**Bid No. 19-240
Addison Airport – U2 and R3 Ramps Rehabilitation**

**Addendum No. 2
To Plans, Contract Documents and Specifications**

PROJECT LAYOUT
 JOB NO.: 19A1100
 DATE: AUG 2019
 DESIGNED BY: KKR
 DRAWN BY: KKR
 BAR IS ONE INCH ON ORIGINAL DRAWING
 IF NOT ONE INCH ON THIS SHEET, ADJUST SCALES ACCORDINGLY.
 DRAWING NUMBER
G-103
 SHEET NUMBER
3

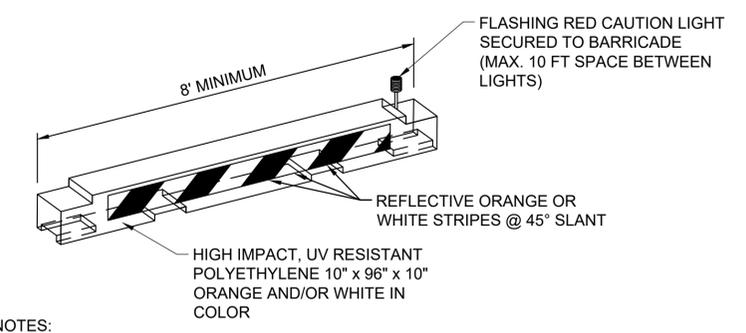
11. What is the concrete washout location for the U2 apron?
 - a. The concrete washout (CW) location for the U2 apron is shown on sheet G-103 within the Addendum No. 2 plan revisions.
 - b. The contractor can recommend alternate locations to be reviewed by the engineer once the construction contract has been awarded.

Plan sheet G-103 was revised to show a concrete washout location for the U2 Apron Rehabilitation.

U2 RAMP DEMOLITION PLAN

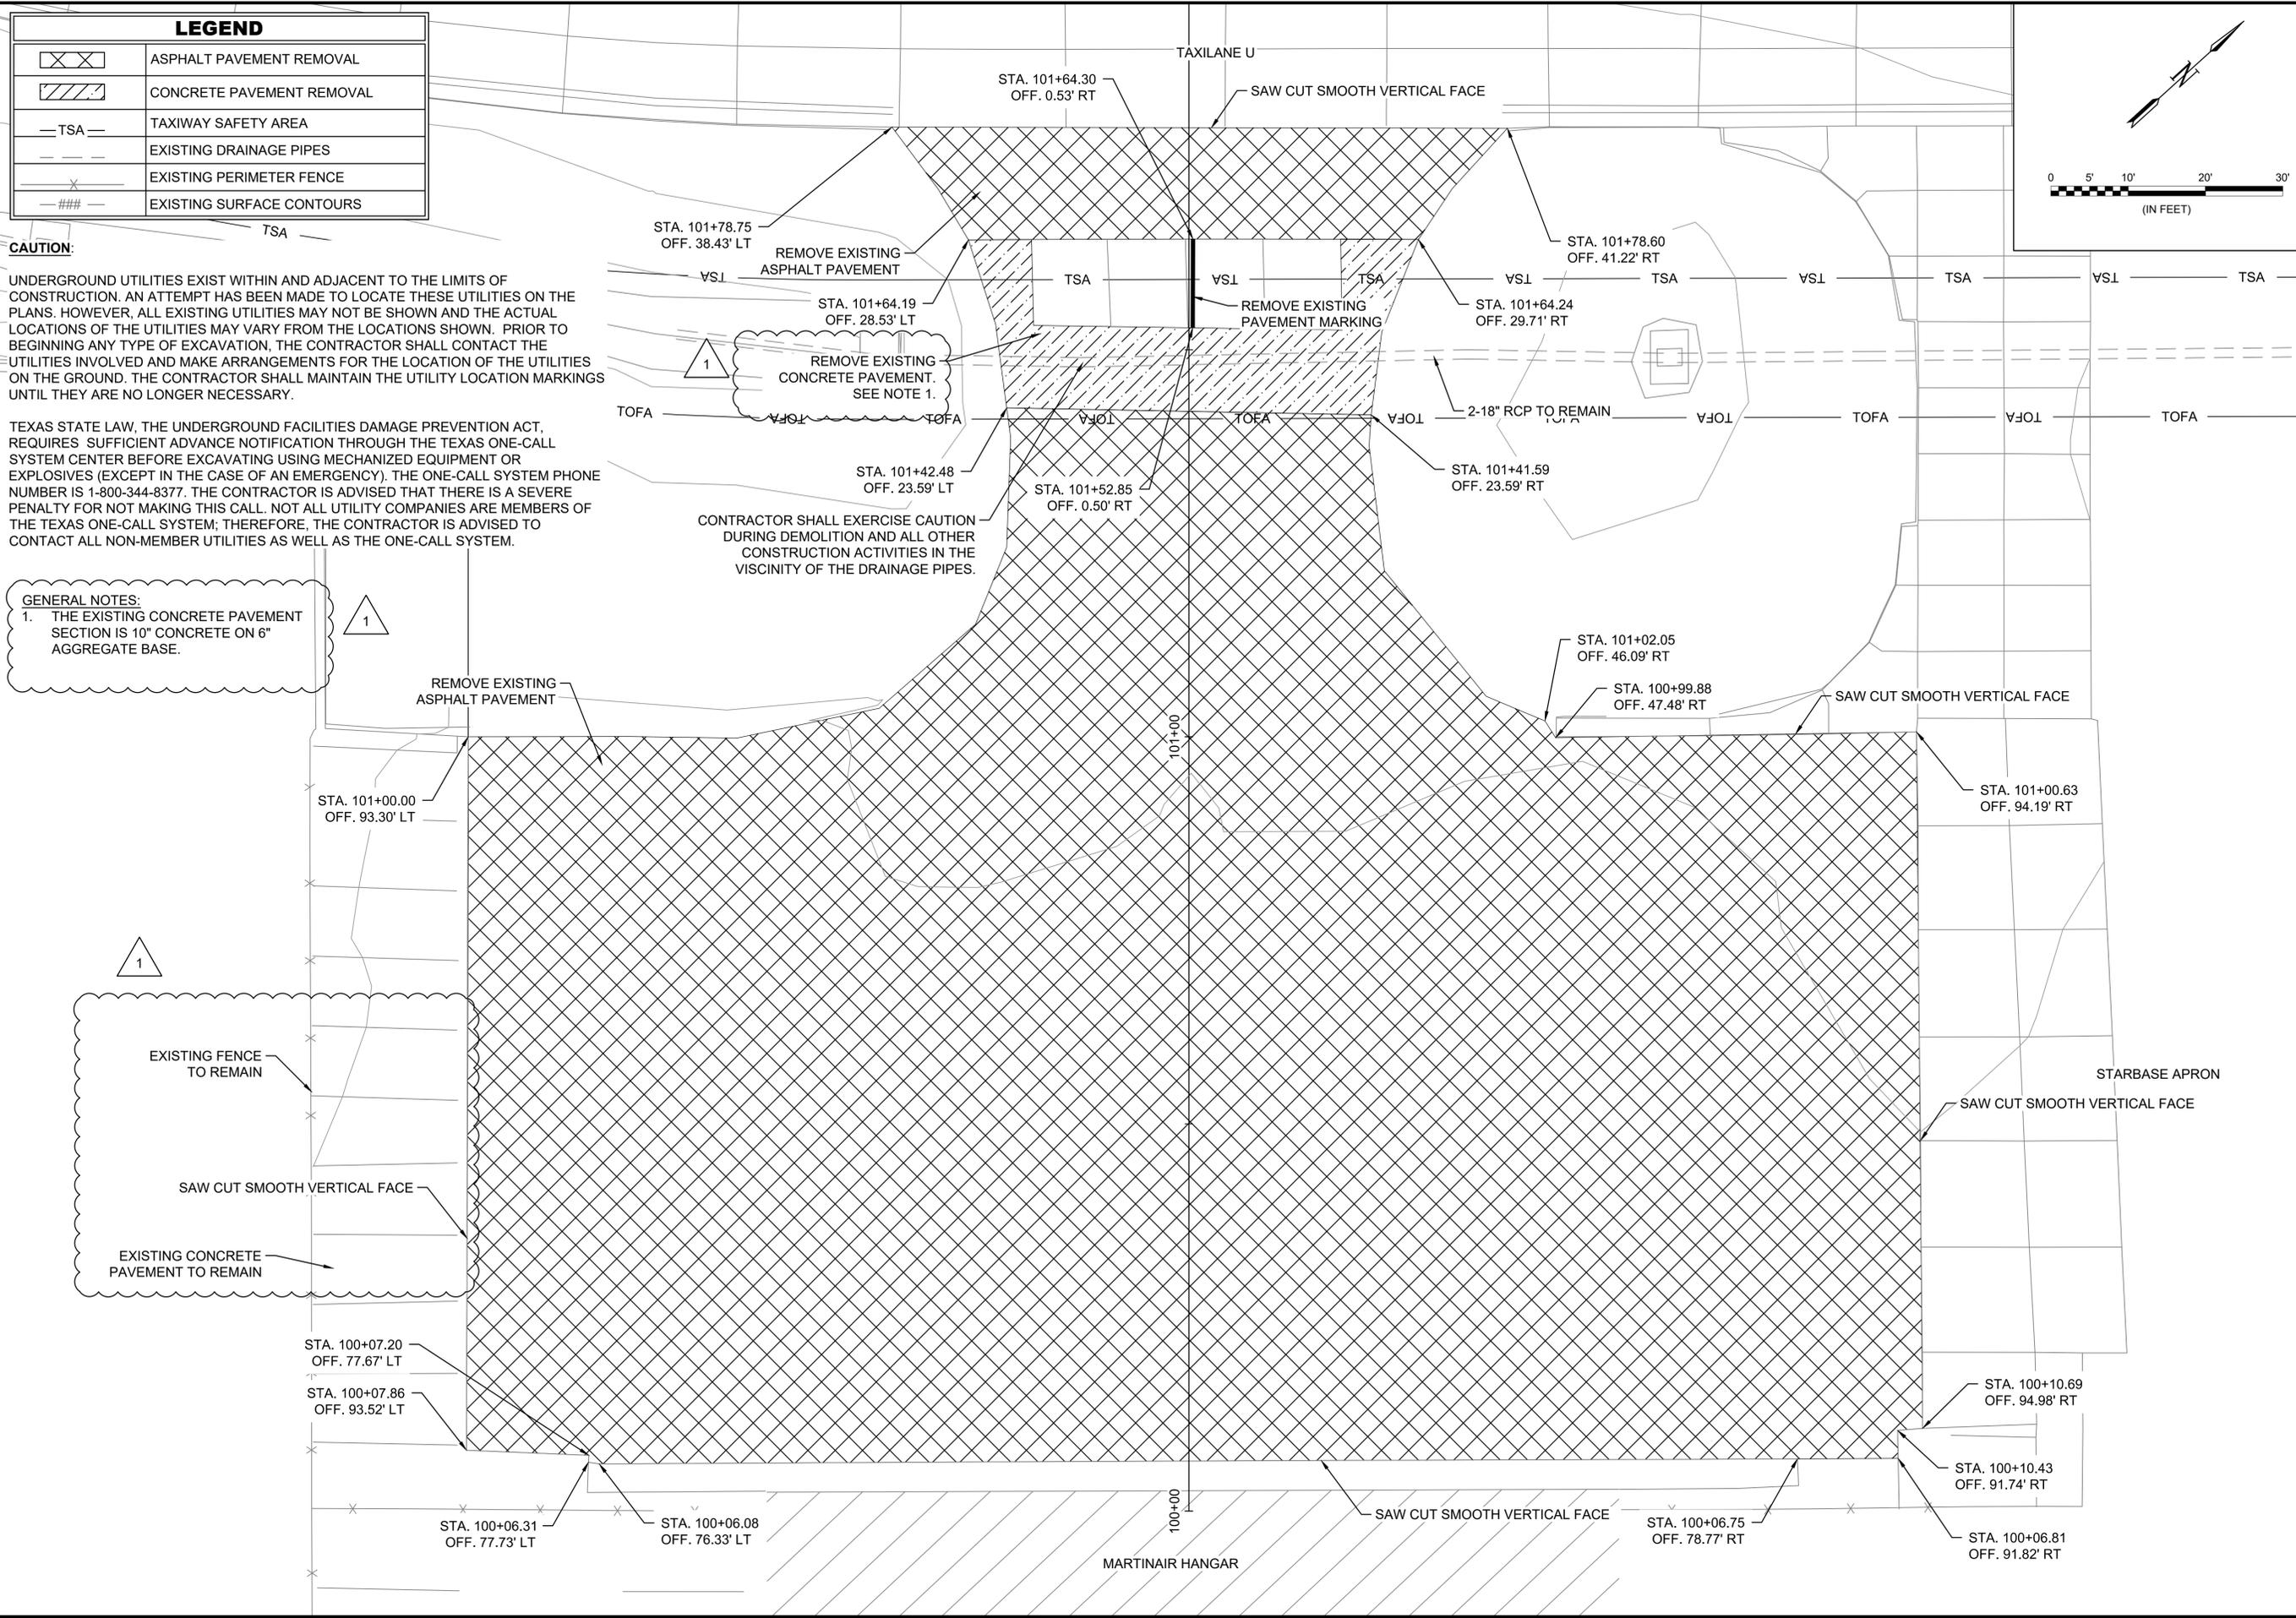
Plan sheet C-101 was revised to provide existing concrete pavement section information.

- THE EXISTING CONCRETE PAVEMENT SECTION IS 10" CONCRETE ON 6" AGGREGATE BASE.

DRAWING NUMBER

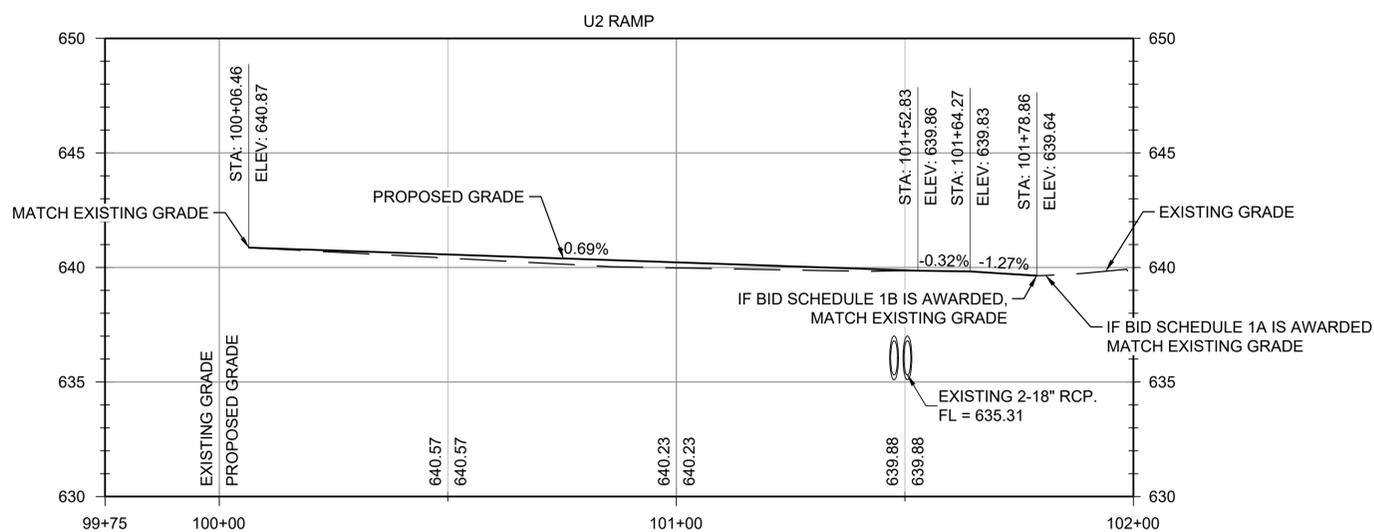
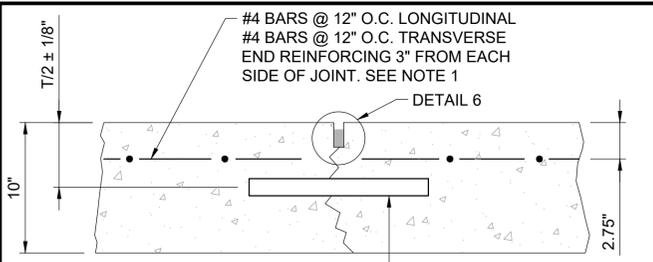
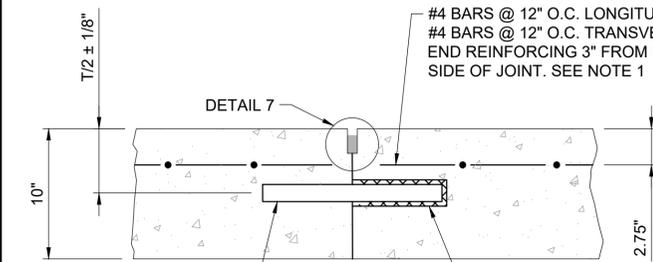
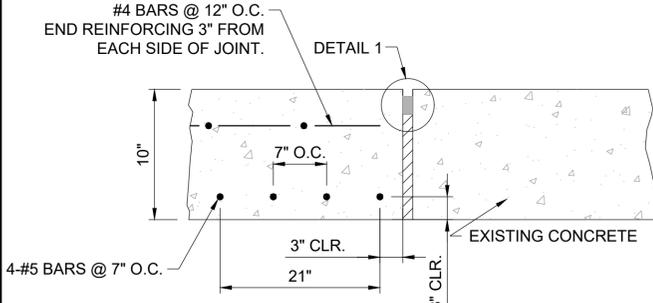
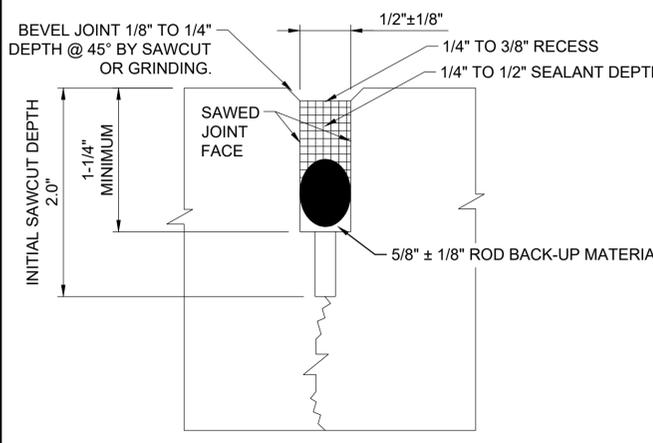
- a. 18" long ,1" dowels will be spaced at 12" on centers.
 - b. Joint and Dowel details have been revised to be included within Addendum No. 2 plan revisions. Please see sheets C-102 and C-104.

Plan sheet C-102 and C-104 were revised to show additional jointing and dowel details for the proposed U2 concrete apron.

SLAB THICKNESS	DOWEL DIAMETER	DOWEL LENGTH	DOWEL SPACING
7.5" TO 12"	1"	18"	12"
